# Technical Service Bulletin

**MODEL(S) AFFECTED: T600/T600e/T600EE Walk-Behind Scrubbers**

**SUBJECT:** **i-Drive Fold-Back UPDATE** - Ref. TSB No. 241 released January 11, 2019. Machine begins to propel very slowly and will not climb an inclined surface during normal operating conditions. This is caused when the i-Drive current load exceeds the set limit which automatically reduces the current flow to protect transaxle motor from overheating, also known as a "fold-back". The machine will not display a fault code when in fold-back mode.

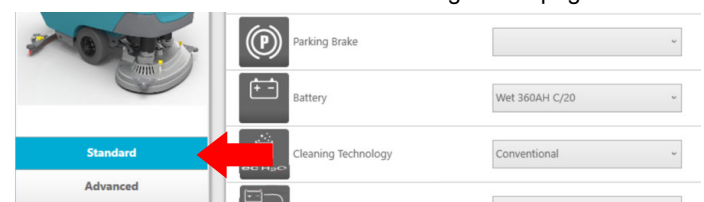
3. Select "Advanced". The "iDrive Config Param Version" will display which iDrive profile requires updating as listed below. Take note of the profile.

10-Default UPDATE NEEDED

11-Parking Brake UPDATE NEEDED

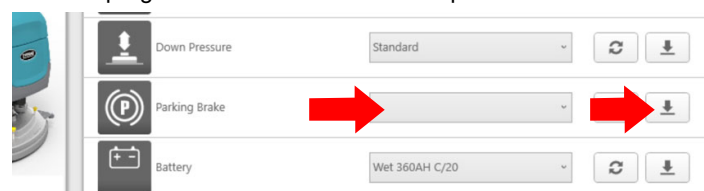
5. For "Parking Brake" selection:

Choose "No" if profile is "10-Default UPDATE NEEDED".

Choose "Yes" if profile is "11-Parking Brake UPDATE NEEDED".

6. Apply the selection by pressing the down arrow. The iDrive will be reprogrammed with new fold-back parameters.
